ADP1850 PCB design error

Figure 2: KiCAD PCB Schematic for ADP1850

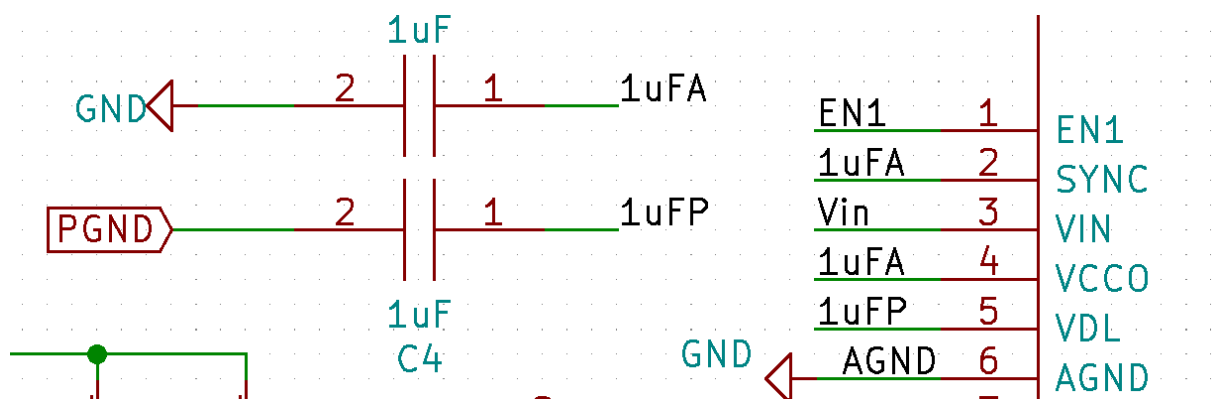
As can be seen in the following figure (Fig. 1), VCCO (Pin no. 4) and VDL (Pin no. 5) need to be shorted for normal operation of ADP1850. The VCCO pin provides 5V supply to the VDL pin which acts as the supply for low side switch gate drivers.

In the PCB Schematic KiCAD files for ADP1850 the two pins were not shorted which has since been rectified. New Gerber files were generated and uploaded to TIFR's GitLab server.

Figure 3: ADP1850 PCB after rectification of error

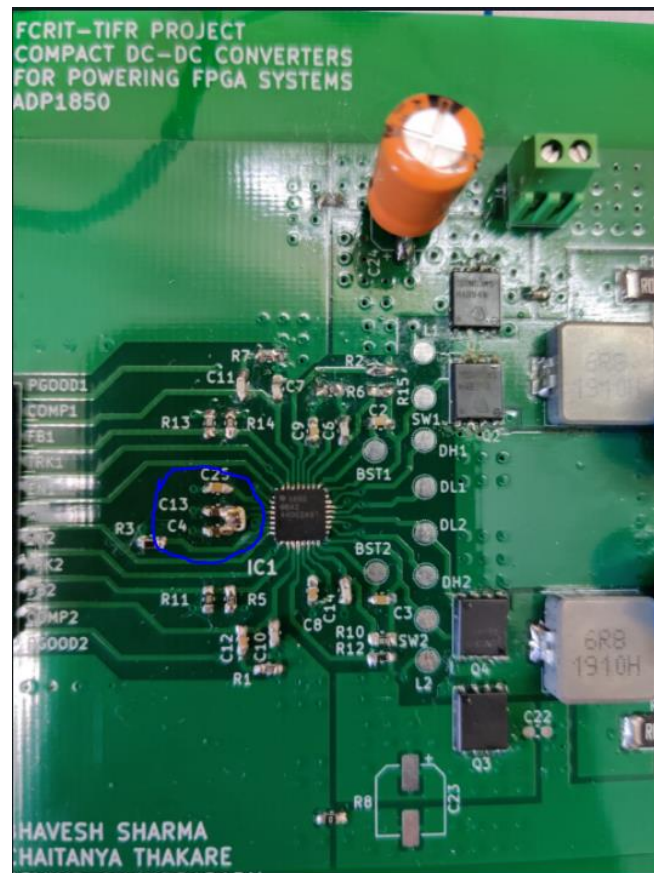
However, since the soldering of ADP1850's PCB was already done before the realization of the mistake, the two pins were shorted using solder wire at the positive terminals of Capacitor C4 and C13 (encircled in blue).
